ADDENDUM NO. 2

August 12, 2022

Additions and Renovations Hawthorne Elementary School

This Addendum consists of Pages ADD 2-1 through ADD 2-3, Specification and Addendum No. 2 from CSO Architects dated August 12, 2022, consisting of three (3) pages, Specification Section 33 06 00 – Aqua-Swirl Stormwater Treatment System, and Addendum Drawing Sheets: AD201A, AD201BC, AD201D, A603, A702, A800, A801A, A801BC and A801D.

DRAWING TITLE:
FIRST FLOOR
DEMOLITION
PLAN - UNIT A

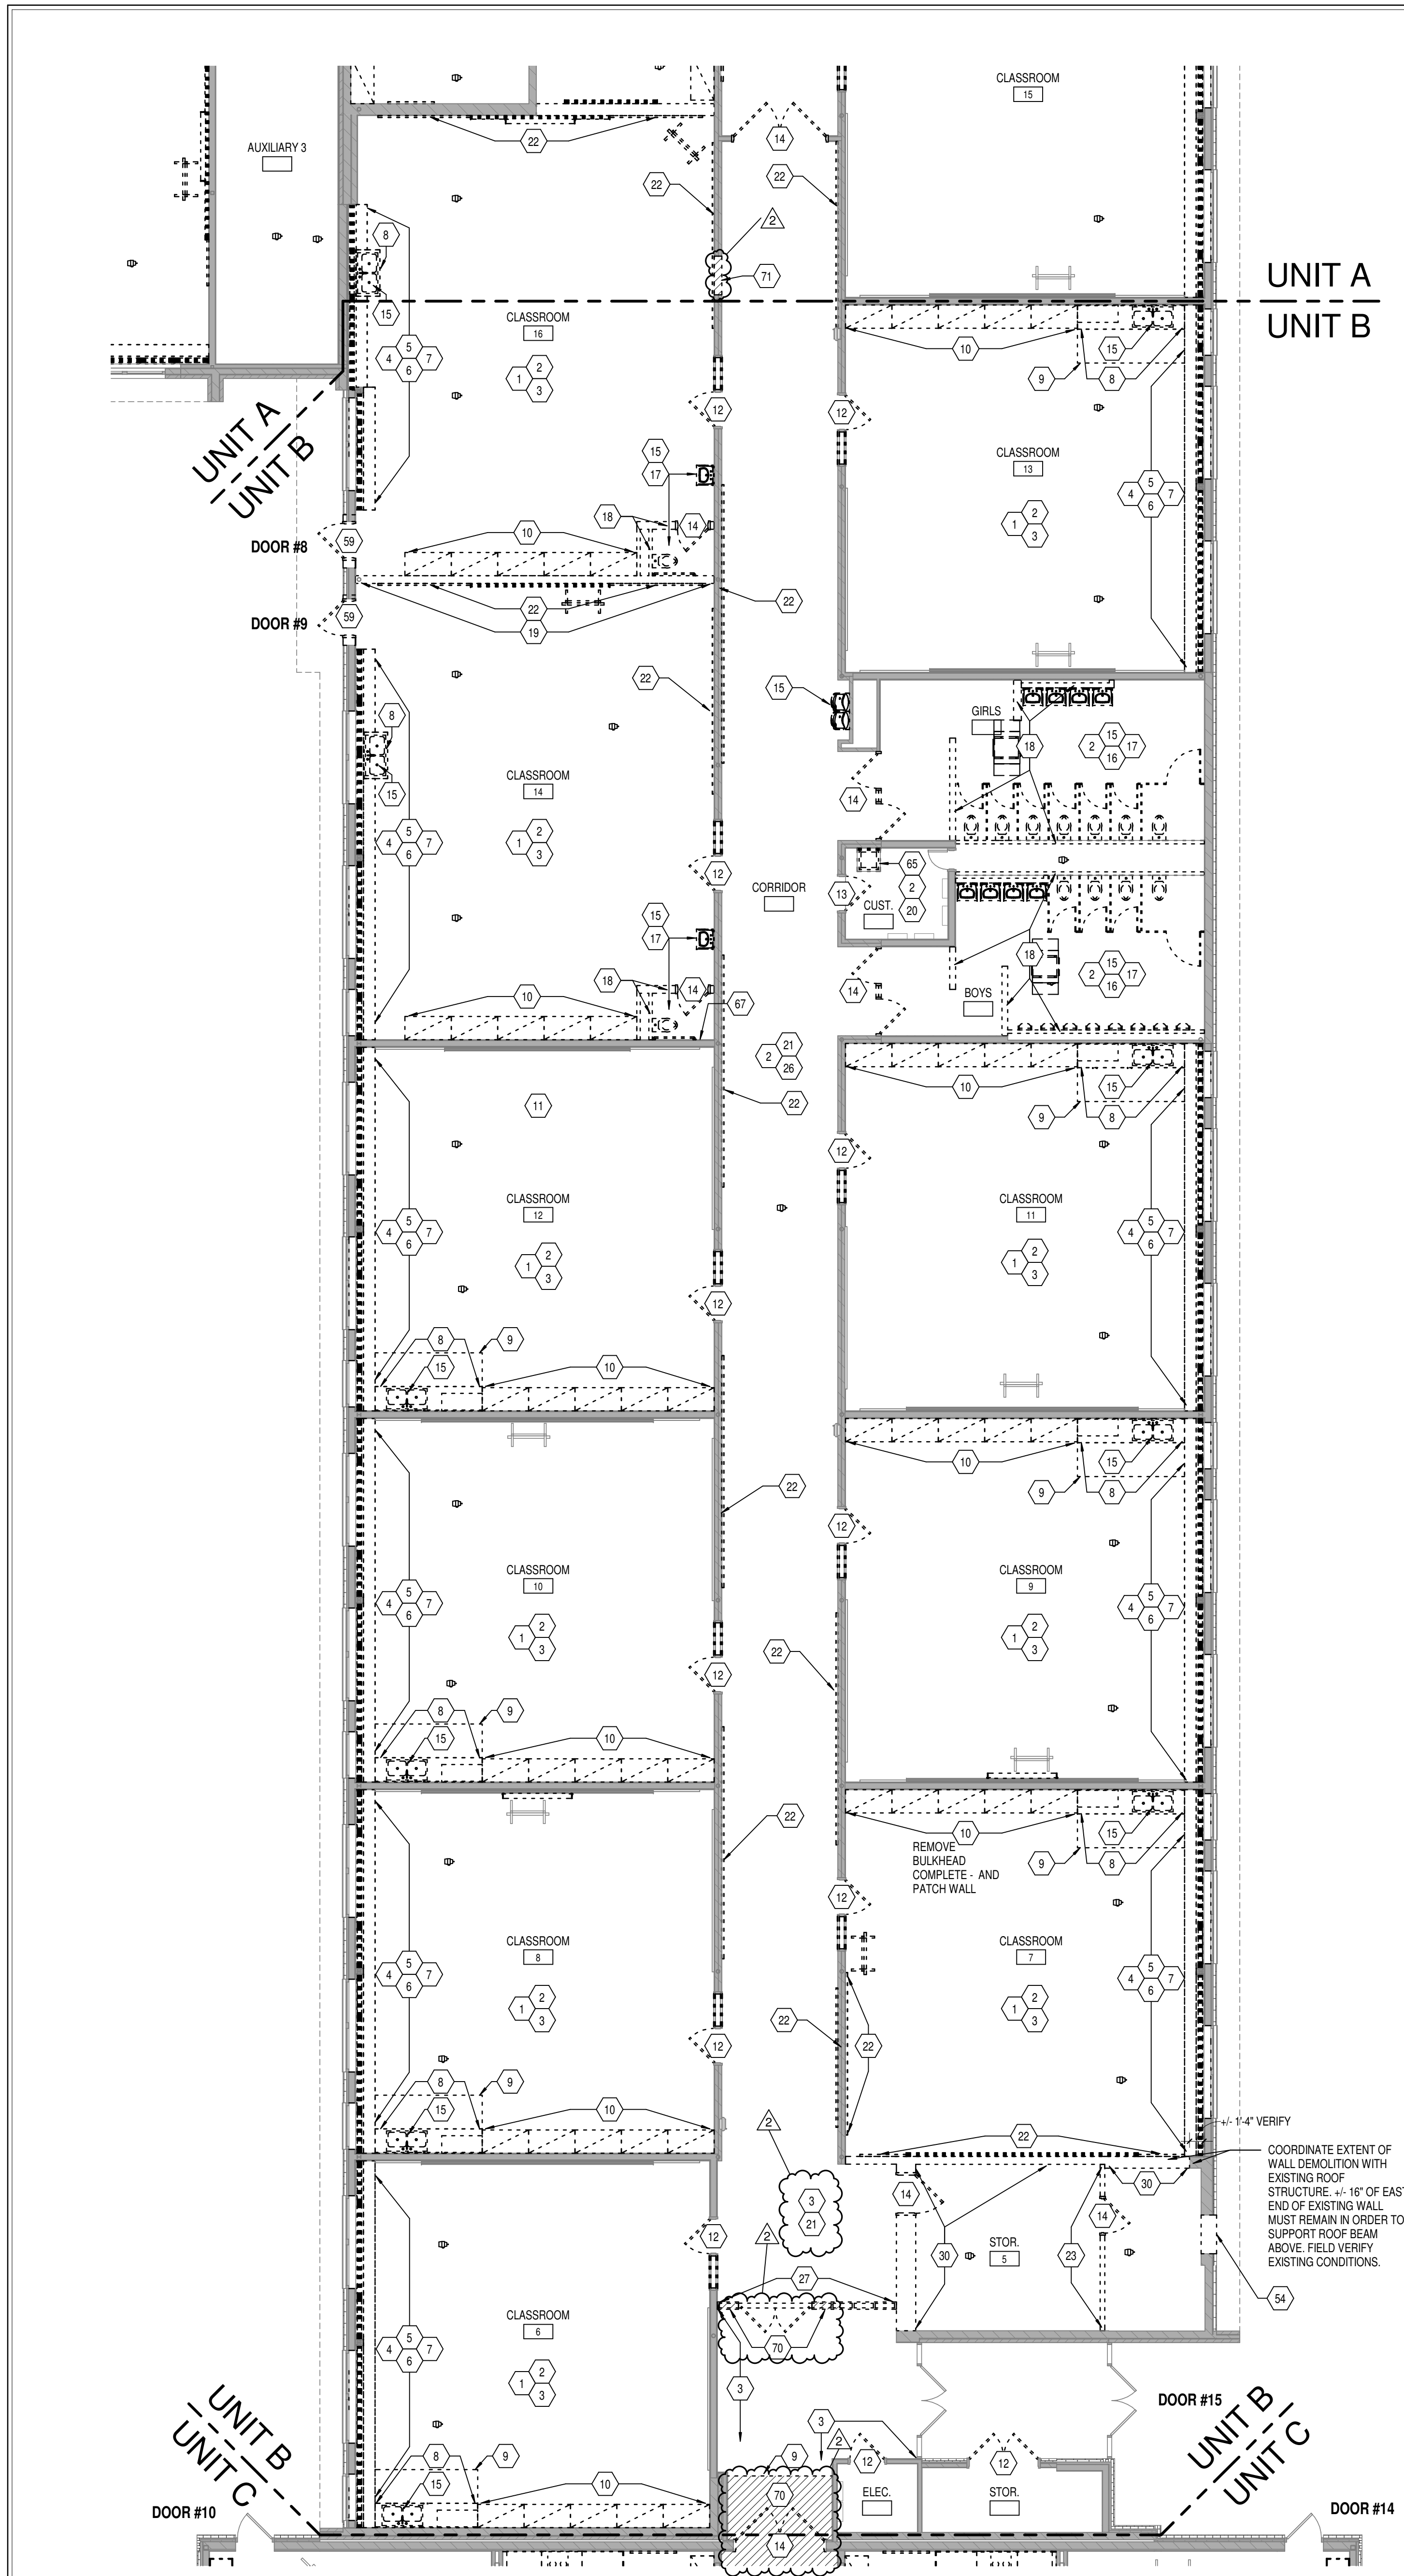
Item 3. (Sheets ED201A,BC,D) Electrical Demolition Plan Notes

Revise plan note #3 to read as follows.

Existing to remain devices on walls that have existing vinyl covering removed are to have receptacle faceplates and receptacle devices removed and replaced with new. Typical of all. Other electrical devices are to be removed and reinstalled with existing coverplates.

DRAWING TITLE:
FIRST FLOOR
FINISH PLAN -
UNIT A

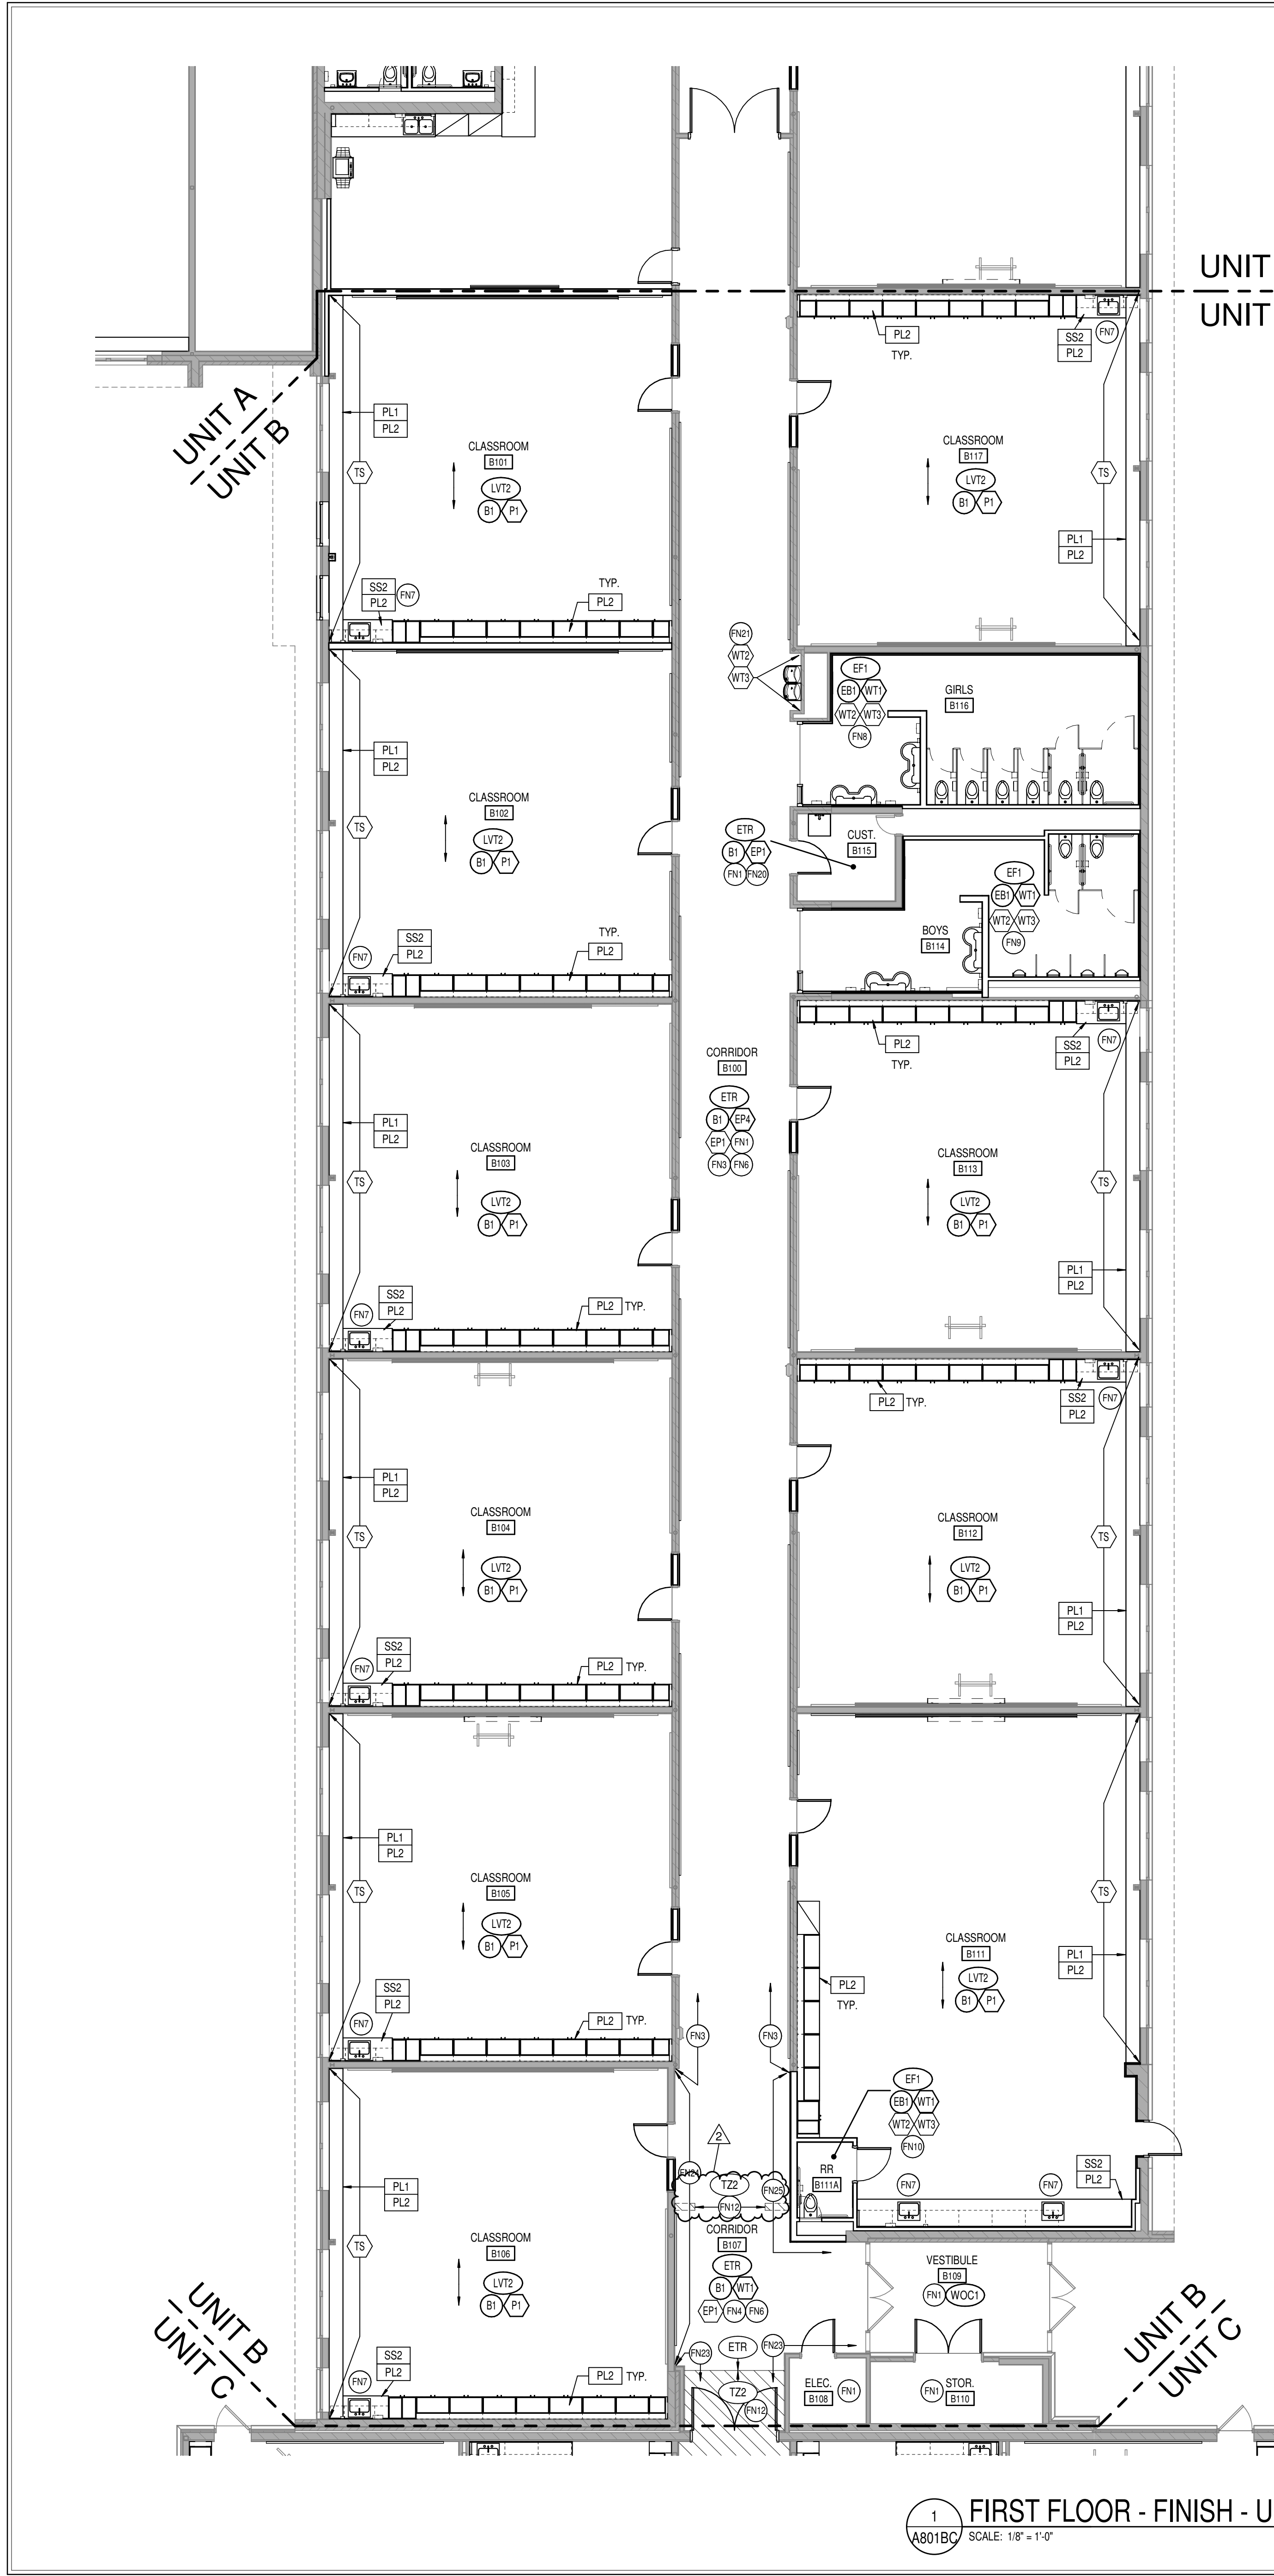
- A. REVISE Keyed Plan Note 14 to read:

“14. Provide new countertop at: Existing to remain perimeter Media Center shelving and wall/shelving at Storytime Area. See Detail 29/A603 and SHEET A801A for new countertops.”
